Appendices Part 5

From: ARCF_SEIS <ARCF_SEIS@usace.army.mil>
Sent: Thursday, February 22, 2024 12:38 PM
To: Sutton, Drew
Cc: publiccommentARCF16@water.ca.gov; ARCF_SEIS
Subject: [EXT] FW: [Non-DoD Source] Comments Regarding American River Common Features (ARCF) 2016 Draft Supplemental Environmental Impact Statement/Subsequent Environmental Impact Report (SEIS/SEIR) – December 2023 Report and Appendices

My comments focus on the lower American River components of the draft SEIS/SEIR, particularly Contracts 3B, and 4A and 4B.

Figure 32: Diagram from "Care of California's Native Oaks"

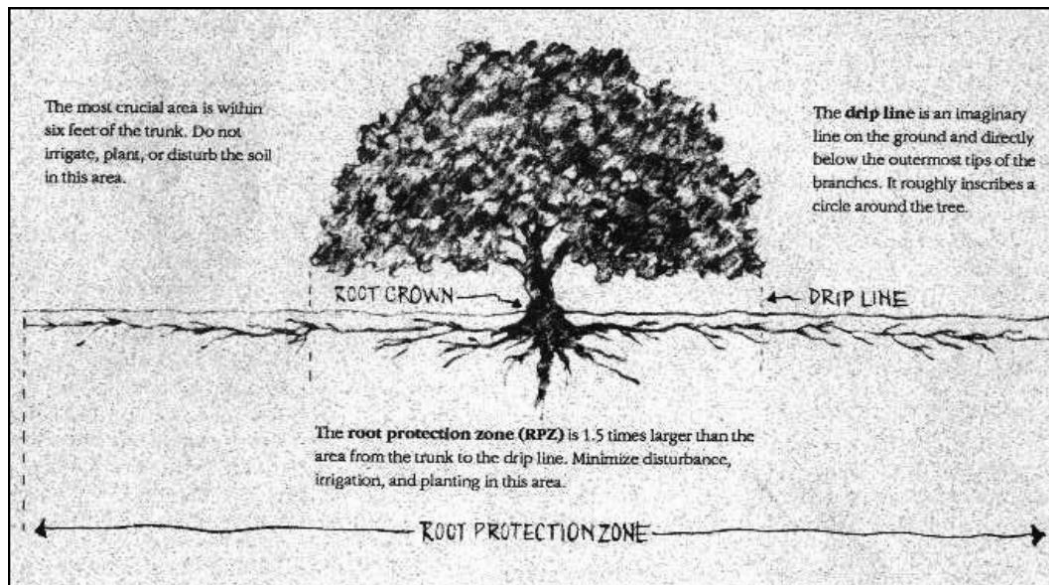
USACE also needs to acknowledge the potential impacts even to heritage trees they plan to "save." It is not enough to simply state whether they will cut down trees. In placing heavy ramps, moving construction equipment back and forth across the banks, and removing most vegetation, USACE's contractors would likely still operate within what the California Oak Foundation calls the "root protection zone" of trees excluded from removal.¹²³ The root protection zone is critical area of an oak tree's roots that is typically 1.5 times the area from the trunk to the dripline.¹²⁴

Figure 4-4. Two-dimensional velocities for a discharge of 115,000 cfs in the Lower American River

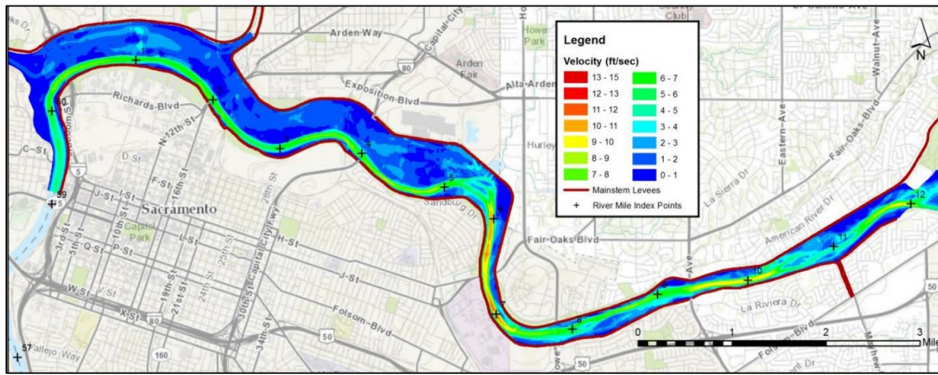
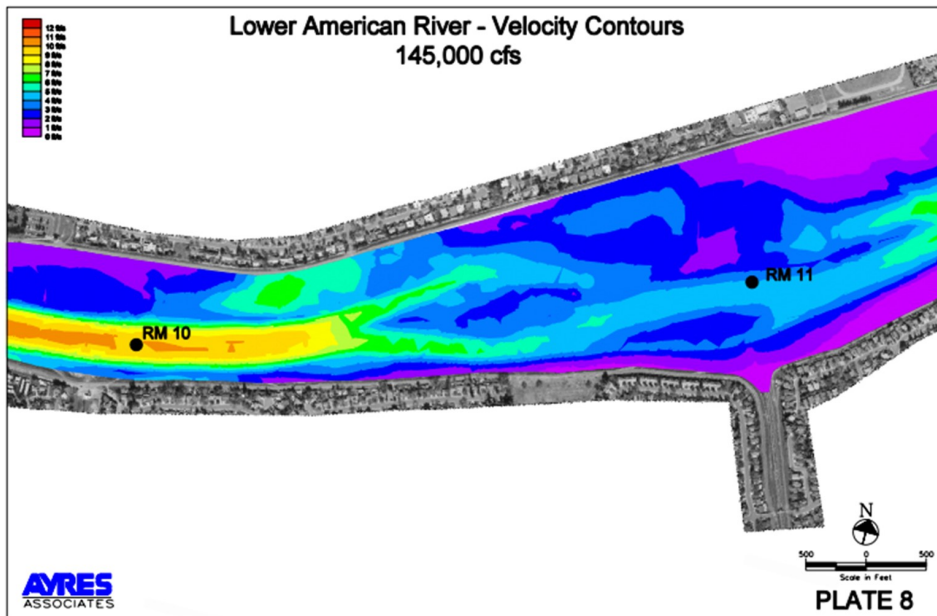
significantly different velocities at river.

Alternate study that shows

Figure 2-8: Velocities in the Lower American River at a discharge of 160,000 cfs

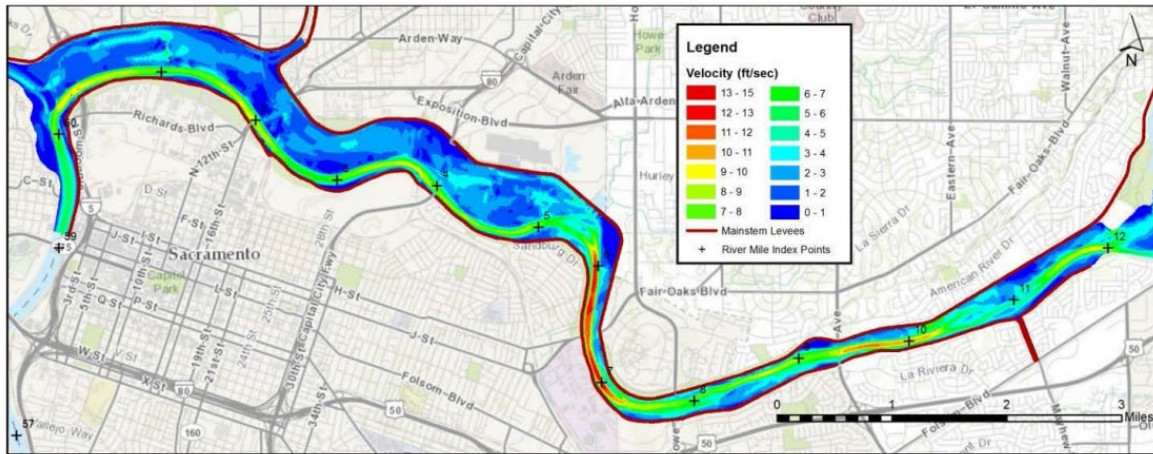
Between left bank river miles 10 and 11, which comprises most of Contract 3B South, estimated velocities along the banks during a 200 year, 160k cfs event range from 0-1 ft/sec to 6-7 ft/sec. At these velocities, there are many types of lining materials for erosion protection USACE could have considered, at least according to table 4-4 of the Erosion Protection Report. The permissible velocity for 6 inch gravel/cobble is 4-7.5 ft/sec, 6-8 ft/sec for class A turf vegetation, and some types of soil bioengineering can withstand up to 19 ft/sec.⁴⁴ Launchable rock riprap, in short, was most certainly not the only option USACE could have deployed. For left bank river mile 10.4-10.5, the consultants who put together the Lower American River Streambank Erosion Monitoring Report recommended “cobble with vegetation or other biotechnical measures such as brush mattress, willow waddles or brush boxes (all supplemented with plantings).”⁴⁵

Figure 3.5.2-3. American River Erosion Contract 3B Project Footprint

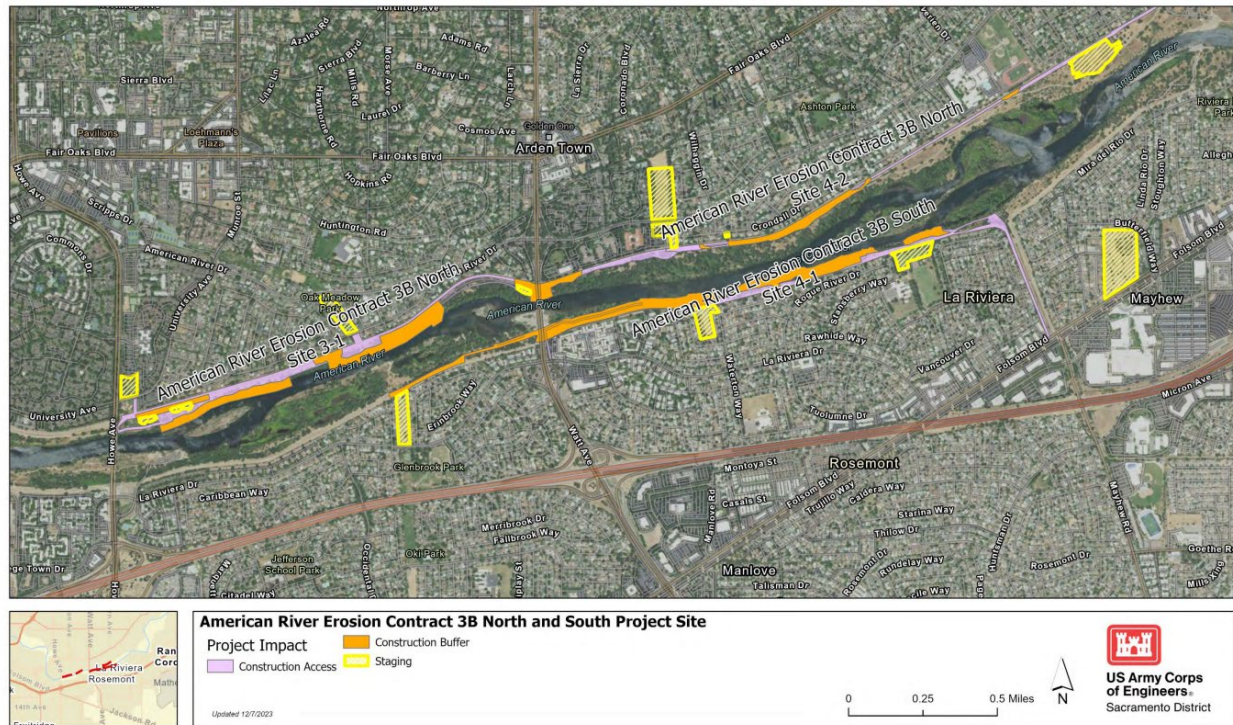
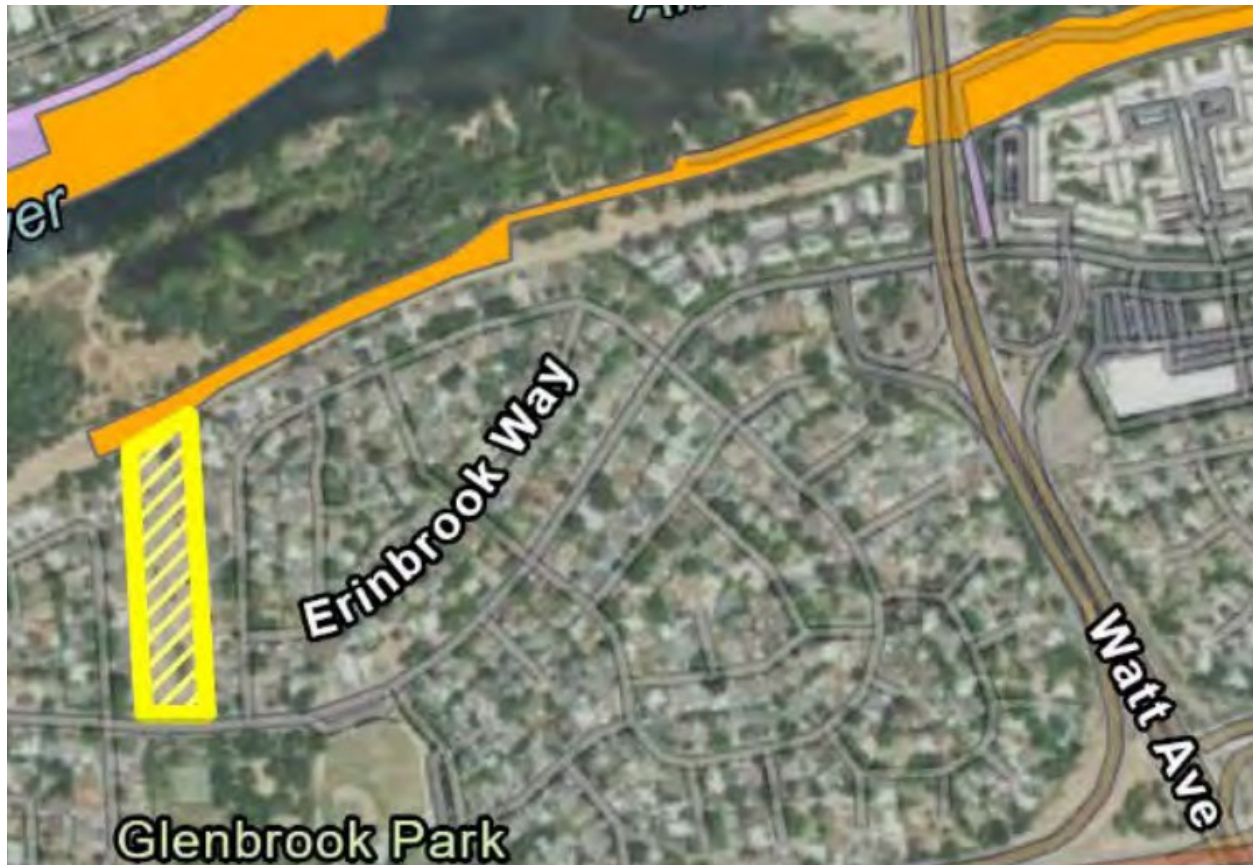
On the south bank (contract 3b south) all the bank protection and launchable rock measures are proposed for the area between Larchmont Community Park and the Watt Bridge. However, there are staging areas to the west of the project area at Glenbrook Park Access and to the east of the Project area at a private parcel. The area between Larchmont Community Park and the Mayhew Canal is colored purple, indicating “construction access.” This makes sense. Though no construction is scheduled between Larchmont Park and the Mayhew Canal, trucks may have to use the canal and the levee leading to Larchmont Park to transport materials to and from the staging area along Folsom Blvd.

As with the area between Larchmont Park and Mayhew Canal, the area between Watt Bridge and Glenbrook River Access is not slated for erosion protection measures, but trucks will need to use this area to transport materials in and out of the project area. Unlike the area between Larchmont Park and Mayhew Canal, the area between Watt and Glenbrook River Access is colored orange, indicating it is a “construction buffer” zone.

Figure 1 Potential erosion sites identified along the LAR by MBK Associates (2018).

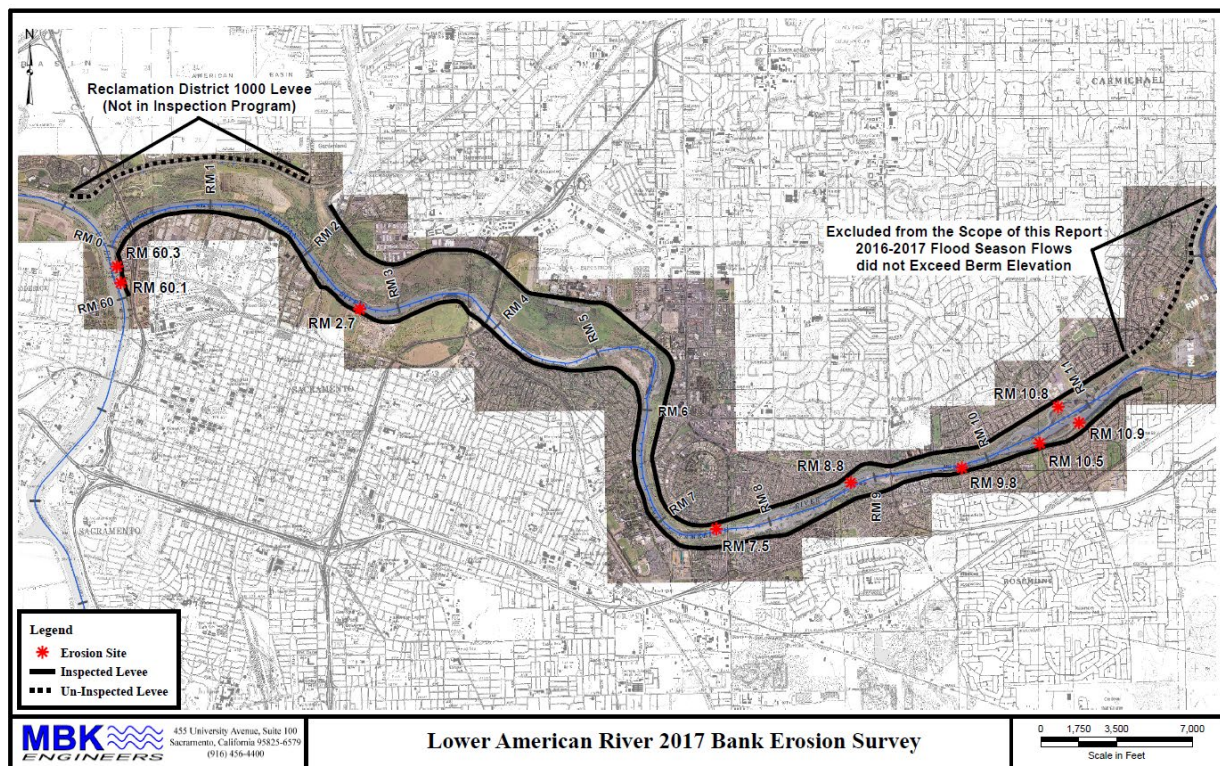
Under the California Environmental Quality Act (CEQA), even where impacts will remain “significant and unavoidable” after mitigation, CEQA requires that all feasible mitigation measures be incorporated (California Public Resources Code§ 21081; 14 CCR§ 15126.2(b)). The draft SEIS/SEIR has not met that requirement. The analysis of alternative methods for a much more surgical, fine-grained approach are not presented. Such alternative methods would result in far less environmental damage. For example, in a study commissioned by the American River Flood Control District & Sacramento Area Flood Control Agency (MBK Associates 2018), the consultants identified seven areas along the LAR that could be vulnerable to erosion during flood events. Over this 11-mile stretch, which is beyond the scope of the current ACE and DWR draft SEIS and SEIR, there is far fewer than six miles of LAR in need of extreme bank hardening (Figure 1).

Figure 2 Modeled river velocity contours for specific reaches of the LAR (river mile 10 to river mile 11) by Ayres Associates (2017)

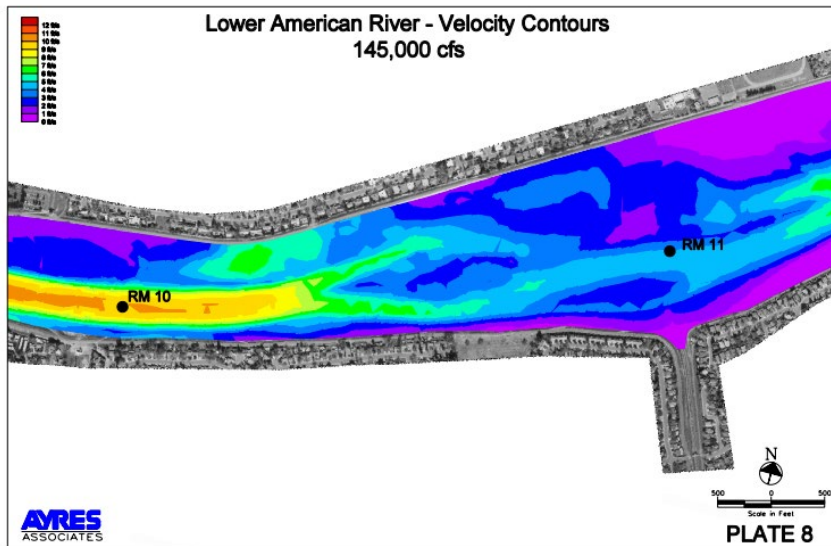
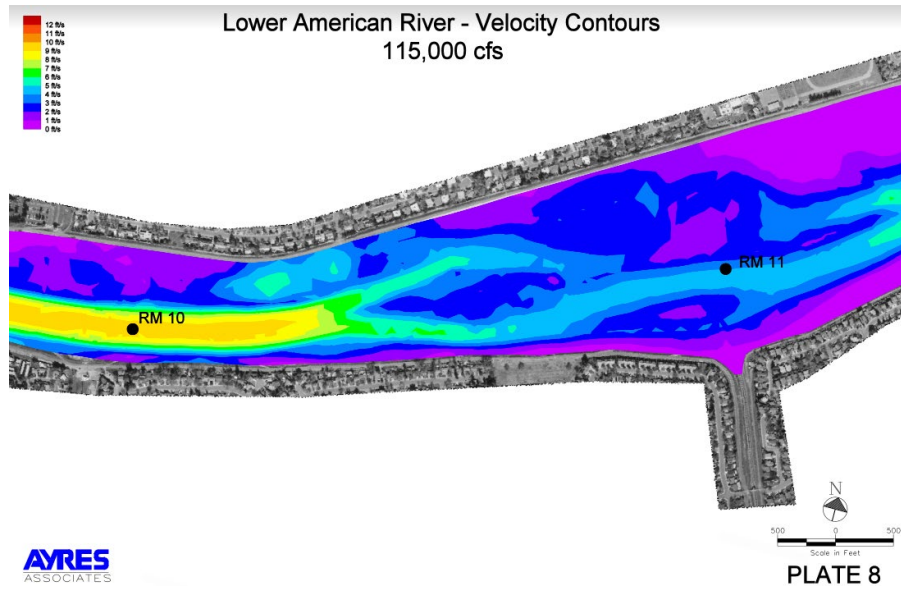
The velocity contours for two flood stage flows in the Ayres Associates' report show that the bank velocities are much lower (1-6 fps) in Figure 2, with shear stress at or below tolerance of intact vegetation ranging from turf grasses to intact native hardwood vegetation (Figure 3).
